IEEE P802.15 Wireless Personal Area Networks

Project	IEEE P802.15 Working Group for Wireless Personal Area Networks (WPANs)	
Title	MSCs Incorporating New FCSL/DME/MLME Functional Division and Imm-ACK Removal	
Date Submitted	[15 July, 2004]	
Source	[John Sarallo] [Appairent Technologies] [150 Lucius Gordon Drive, West Henrietta, NY 14586]	Voice: [585-727-2014] Fax: [585-214-2461] E-mail: [sarallo@appairent.com]
Re:		
Abstract	[This document contains a list or proposed changes to IEEE Std 802.15.3.]	
Purpose	[The purpose of this document is to propose changes to IEEE Std 802.15.3 to improve compatibility, performance and clarity in the standard.]	
Notice	This document has been prepared to assist the IEEE P802.15. It is offered as a basis for discussion and is not binding on the contributing individual(s) or organization(s). The material in this document is subject to change in form and content after further study. The contributor(s) reserve(s) the right to add, amend or withdraw material contained herein.

1. Introduction

Figure 125 - MSC of a DEV synchronizing with a PNC

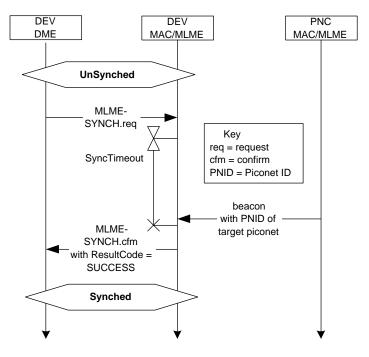
• DME can sync itself because it receives beacon indications. Therefore, MLME-SYNCH primitives are no longer needed.

Figure 102 - MSC of DEV-2 associating

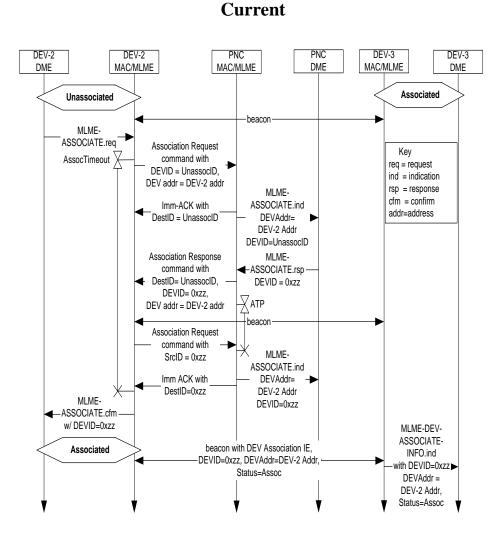
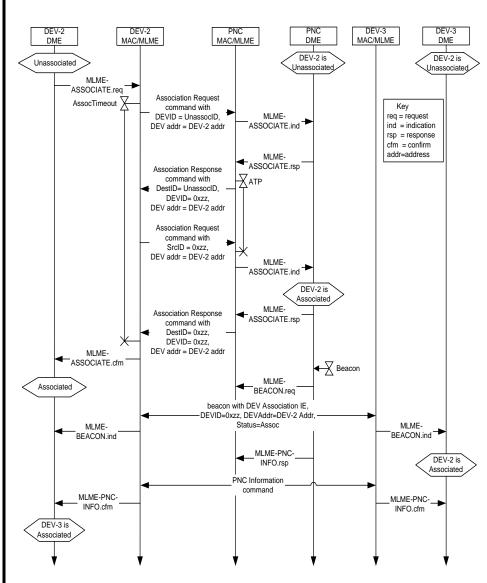
Requesting DEV knows it is associated when it receives the second Association Response command. Other DEVs in the piconet know when they receive a beacon with a DEV Association IE. The associating DEV learns of other DEVs via the PNC Information command.

Figure 103 - PNC sending the Piconet Services command to a newly associated DEV in response to a request in the association process

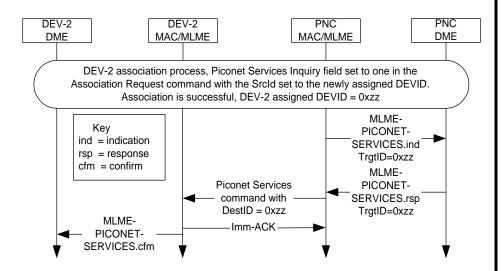
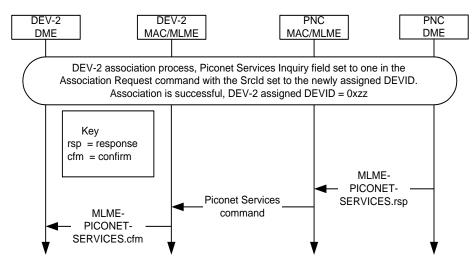
PME is aware when a DEV associates with the Piconet Services Inquiry field set therefore the PNC MAC/MLME does not need to send an indication to the PME.

Figure 104 - DEV initiated disassociation MSC

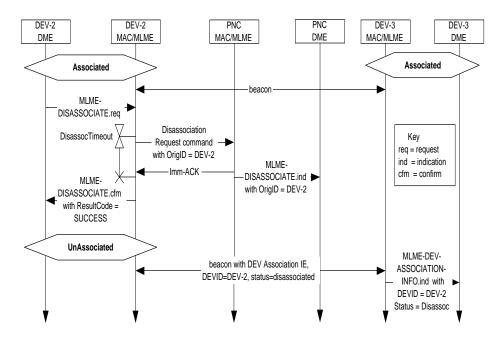
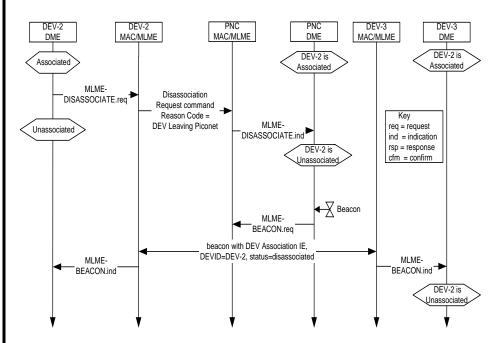
- DEV initiated disassociation is a "fire and forget" scenario.
- Disassociating DEV can immediately mark itself as disassociated.
 Other DEVs know when they receive a beacon with a DEV Association IE.

Figure 105 - PNC initiated disassociation MSC

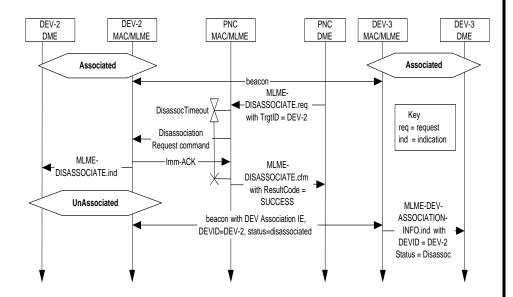
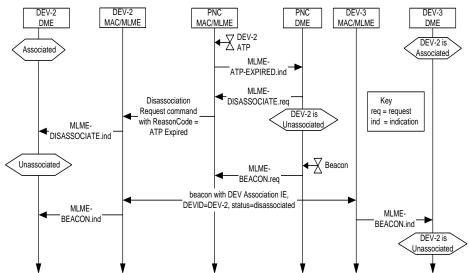
- PNC initiated disassociation is a "fire and forget" scenario.
- DEV is disassociated when it receives a MLME-DISASSOCI-ATE.ind. Other DEVs know about the disassociation when they receive a beacon with a DEV Association IE.
- If a DEV receives a beacon with a DEV Association IE indicating it is disassociated, it should consider itself disassociated.
- Took opportunity to add MLME-ATP-EXPIRED.ind to at least one MSC (Note: MAC/MLME must maintain ATP timers because the DME does not see data frames.)

Figure 114 - MSC for creating a DEV-2 to DEV-3 stream

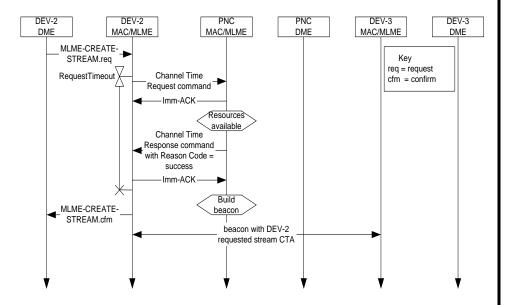
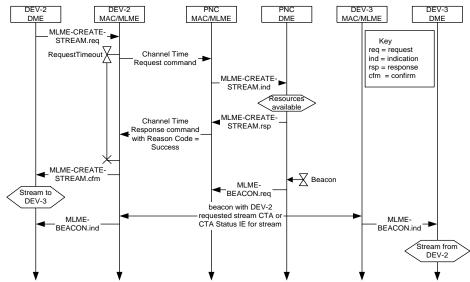
- PME is responsible for channel time allocation so MLME-CREATE-STREAM indication and response primitives are required.
- Requesting DEV knows stream is created when it receives the Channel Time Response command.
- Target DEV knows about the stream when it receives a beacon with a CTA or CTA Status IE indicating it is the target of a stream.

Figure 117 - MSC for modifying a stream

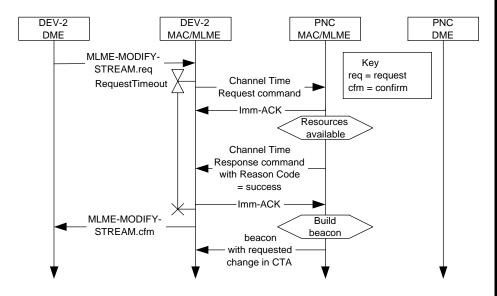
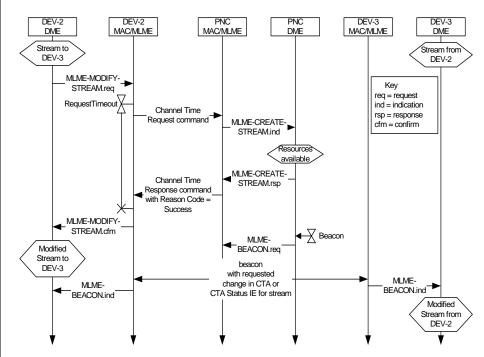
- Requesting DEV knows stream is modified when it receives the Channel Time Response command.
- Target DEV knows about the stream modification when it receives a beacon with a modified CTA or a CTA Status IE.

Figure 120 - MSC of source DEV-2 requesting termination of its stream

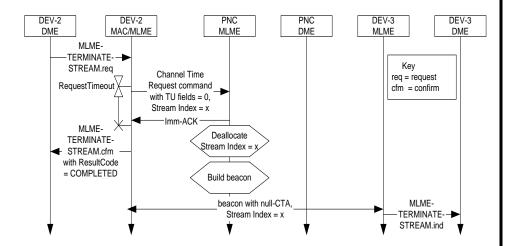
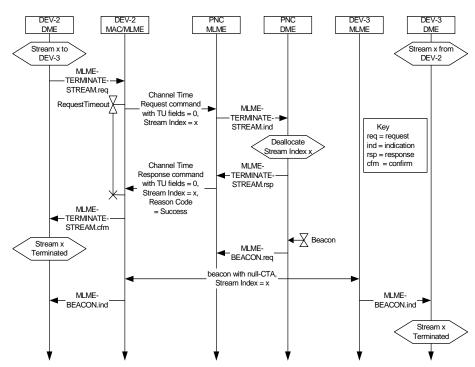
• If the we desire the target to know why a stream was terminated, then the target DEV must receive a Channel Time Response command. Otherwise, it will know the stream is terminated when it receives the Null CTA but it will not know why the stream was terminated.

Figure 121 - MSC of target DEV-3 requesting termination of source DEV-2's stream

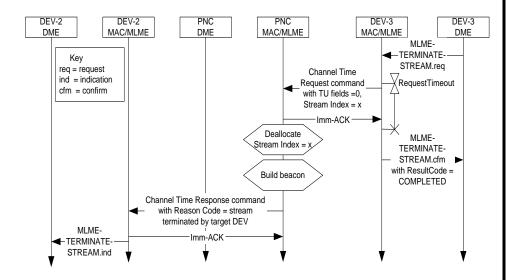
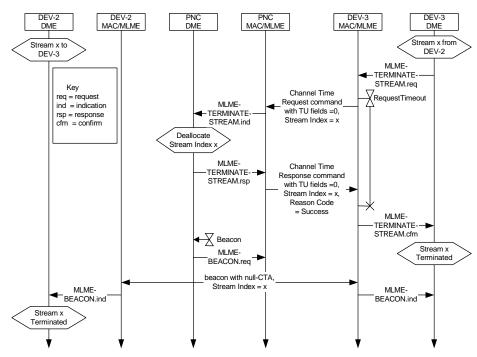
If the we desire the strean source to know why the stream was terminated, then the source DEV must receive a Channel Time Response command. Otherwise, it will know the stream is terminated when it receives the Null CTA but it will not know why the stream was terminated.

Figure 122 - MSC of PNC terminating a stream

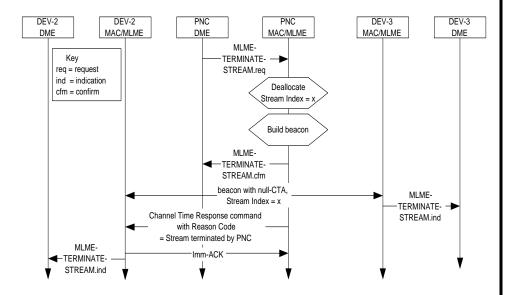
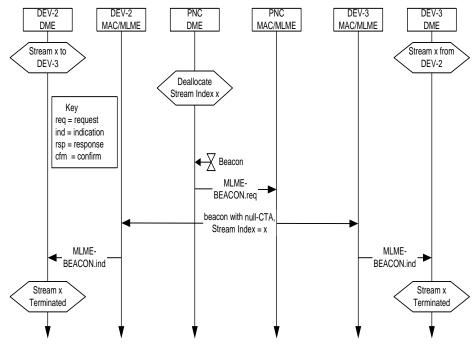
• If the we desire the stream source and target to know why a stream was terminated, then both DEVs must receive a Channel Time Response command. Otherwise, both DEVs will know the stream is terminated when they receives the Null CTA but they will not know why the stream was terminated.

Figure 127 - MSC for acquiring information regarding a specific DEV or all of the DEVs from the PNC using the PNC Information Request and PNC Information commands

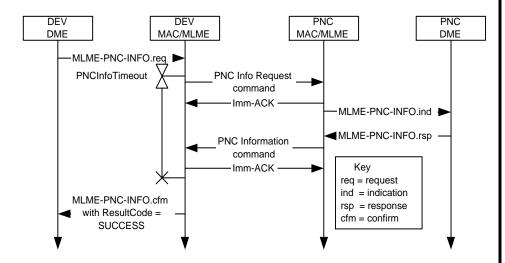
• Only change is Imm-ACKs removed.

Figure 130 - MSC for determining the channel status between two DEVs using the Channel Status Request and Channel Status Response commands

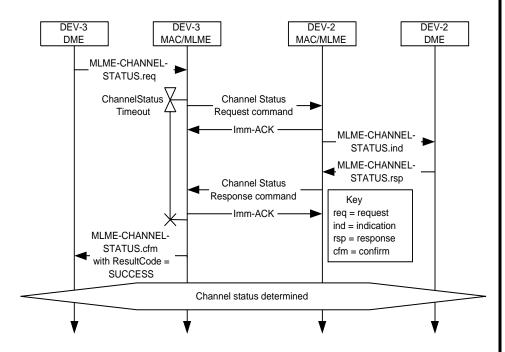
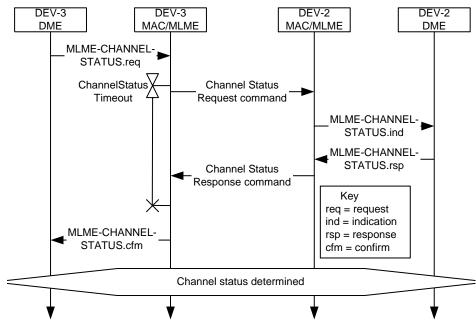
• Only change is Imm-ACKs removed.

Figure 131 - Remote scan MSC

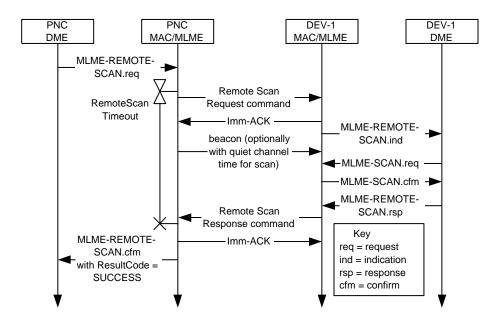
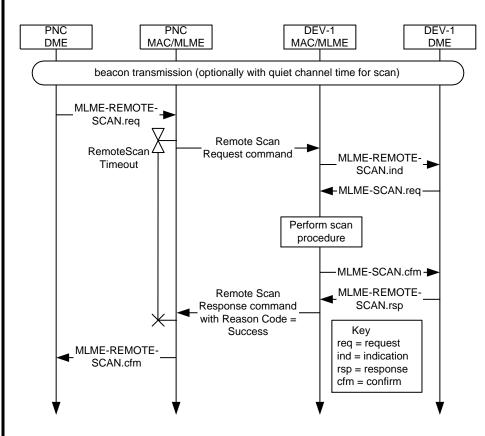
• Only real change is Imm-ACKs removed.

Figure 134 - MSC for changing either the PNID or BSID for a piconet

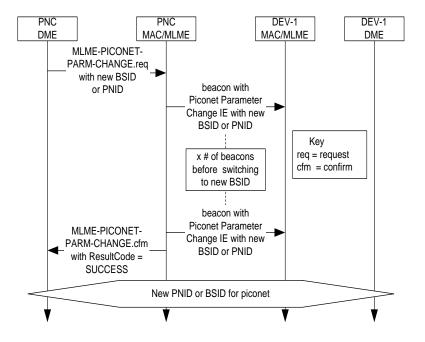
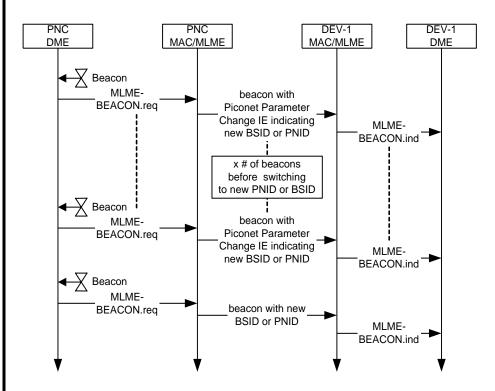
PME is responsible for information in the beacon so the MLME-PICONET-PARM-CHANGE primitives are no longer needed.

Figure 136 - Transmit power change MSC

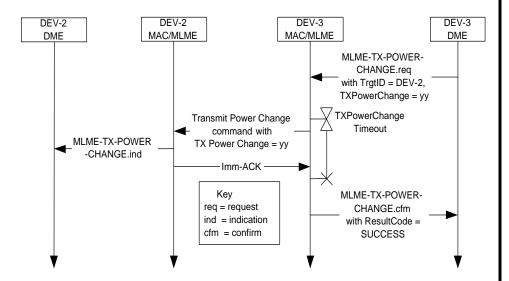
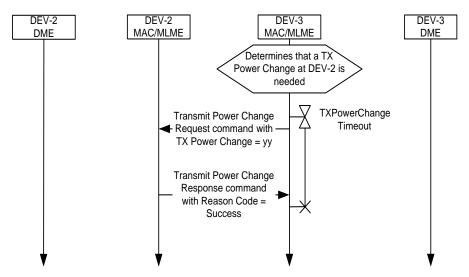
• MAC/MLME responsible for TX power adaptation, therefore MLME-TX-POWER-CHANGE primitives are no longer needed.

Figure 140 - MSC for PS set information exchange

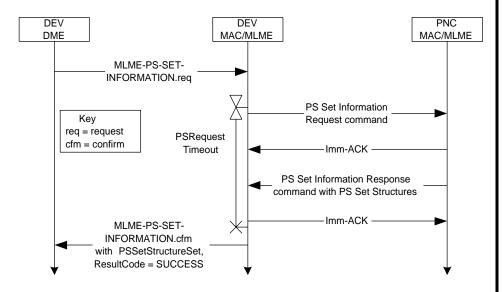
PME is responsible for maintaing power set information, therefore, MLME-PS-SET-INFORMATION indication and response primitives are needed.

Figure 141 - MSC for DSPS set creation

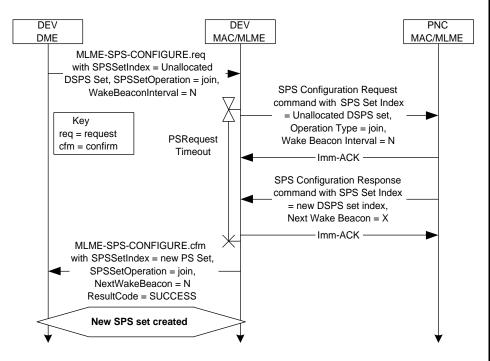
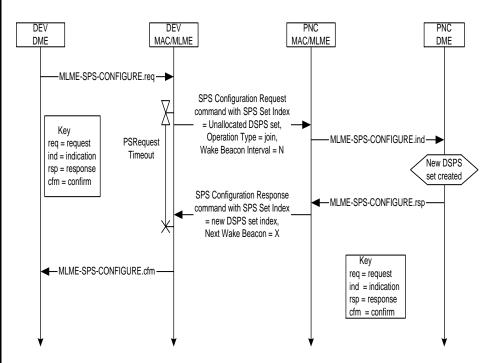
PME is responsible for maintaing power set information, therefore, MLME-SPS-CONFIGURE indication and response primitives are needed.

Figure 142 - MSC showing a DEV joining an existing SPS set

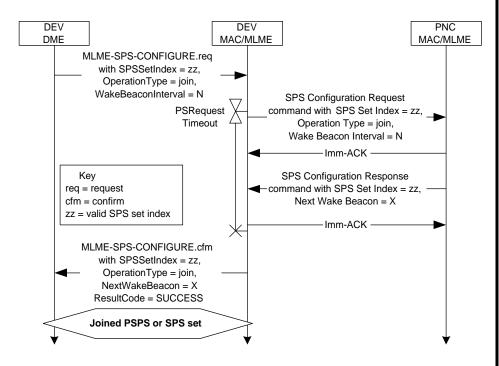
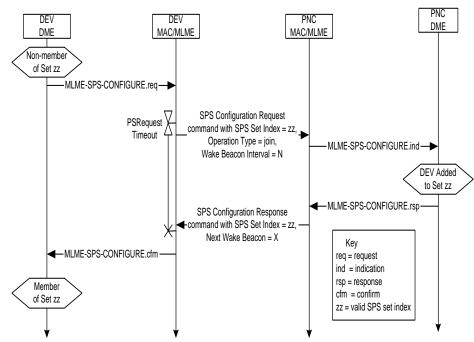
PME is responsible for maintaing power set information, therefore, MLME-SPS-CONFIGURE indication and response primitives are needed.

Figure 143 - MSC showing a DEV leaving an SPS set

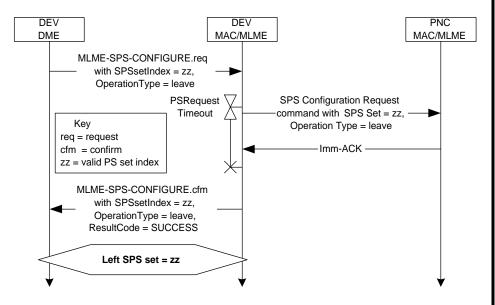
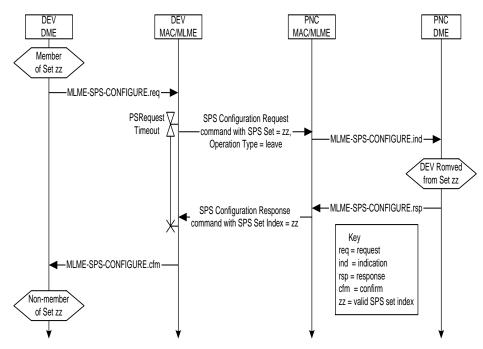
PME is responsible for maintaing power set information, therefore, MLME-SPS-CONFIGURE indication and response primitives are needed.

Figure 144 - MSC showing DME initiated PM mode change from ACTIVE to an SPS mode

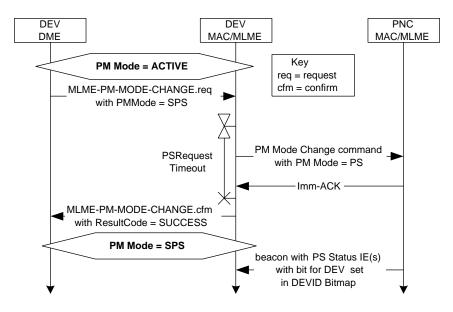
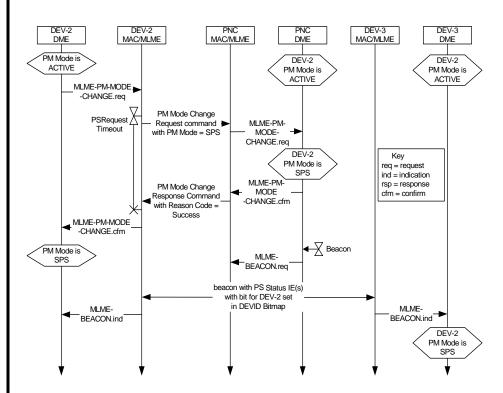
- PME is responsible for maintaing power save state information, therefore, MLME-PM-MODE-CHANGE indication and response primitives are needed.
- Other DEVs aware of mode change when they receive beacon.

Figure 145 - MSC showing DME initiated PM mode change from ACTIVE to APS

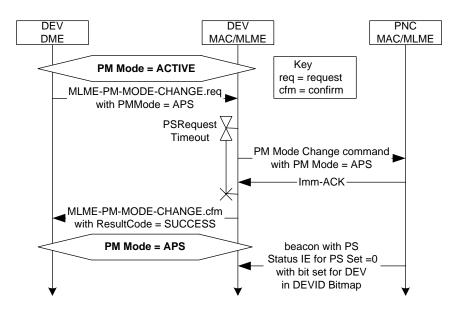
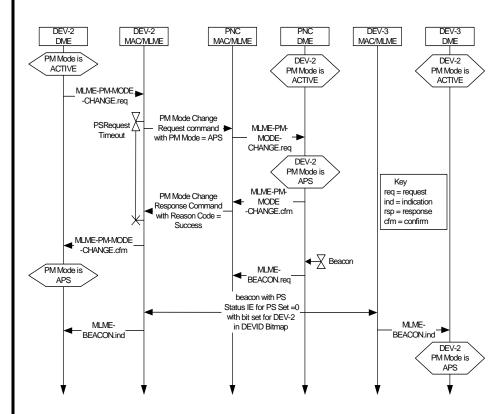
- PME is responsible for maintaing power save state information, therefore, MLME-PM-MODE-CHANGE indication and response primitives are needed.
- Other DEVs aware of mode change when they receive beacon.

Figure 146 - MSC showing DME initiated PM mode change from any PS mode to ACTIVE

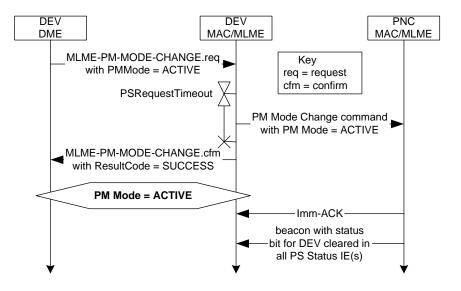
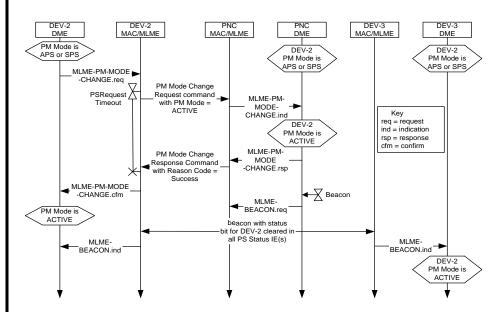
- PME is responsible for maintaing power save state information, therefore, MLME-PM-MODE-CHANGE indication and response primitives are needed.
- Other DEVs aware of mode change when they receive beacon.

Figure 147 - Message sequence showing MLME initiated PM mode change from DSPS to ACTIVE in response to a new chanel time allocation

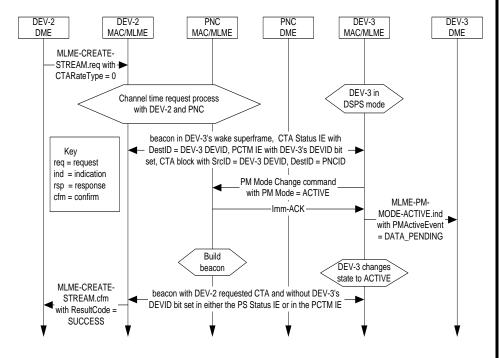
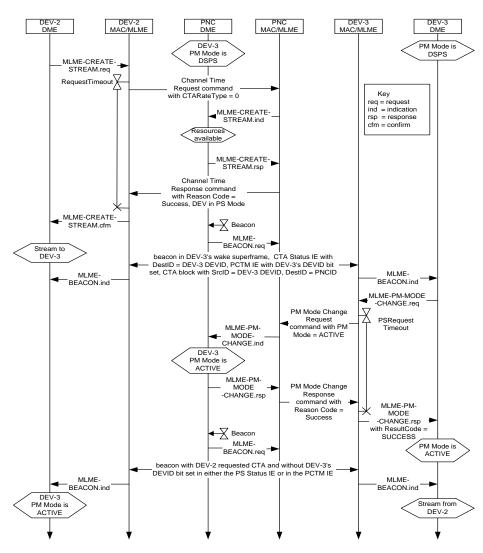
• To be consistent with other scenarios, requesting DEV is aware of stream when it receives a Channel Time Response command.

Figure 150—Message sequence chart for sending security information with the Security Message command

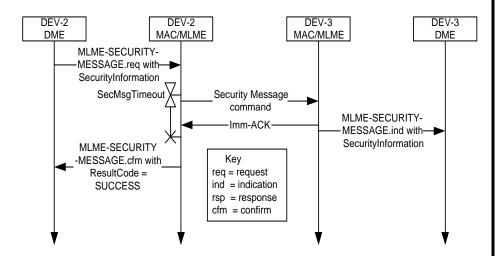
• Fire and forget so no confirm is needed.

Figure 101 - MSC for initiating a neighbor piconet

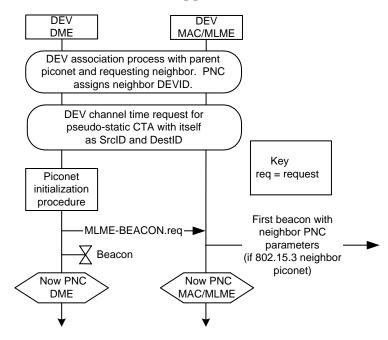
- The PME (PNC DME) maintains the information that is contained in a beacon so a MLME-START primitive is no longer needed because the PME can simply make a request to send a beacon when it is ready to start a piconet.
- When a piconet is started, a Beacon timer is required for transmitting beacons at the superframe interval.

Figure 94 - PNC handover MSC

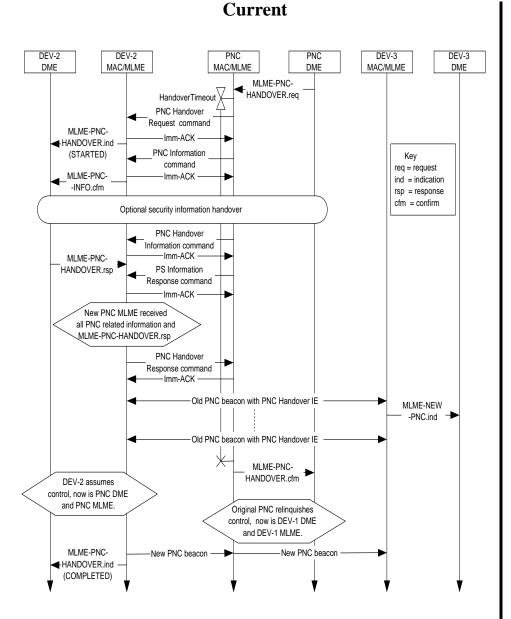
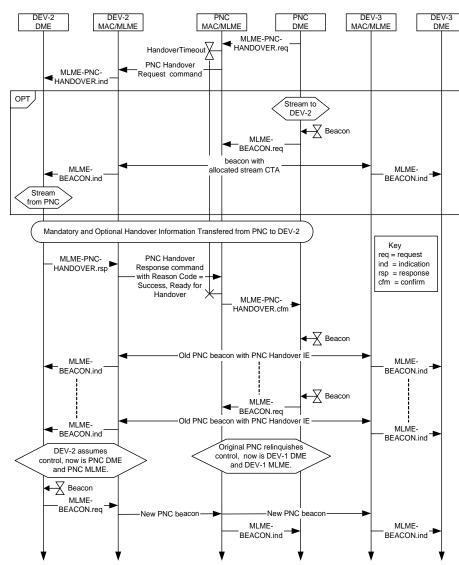
• Shows handover data is optionally transferred in a stream.
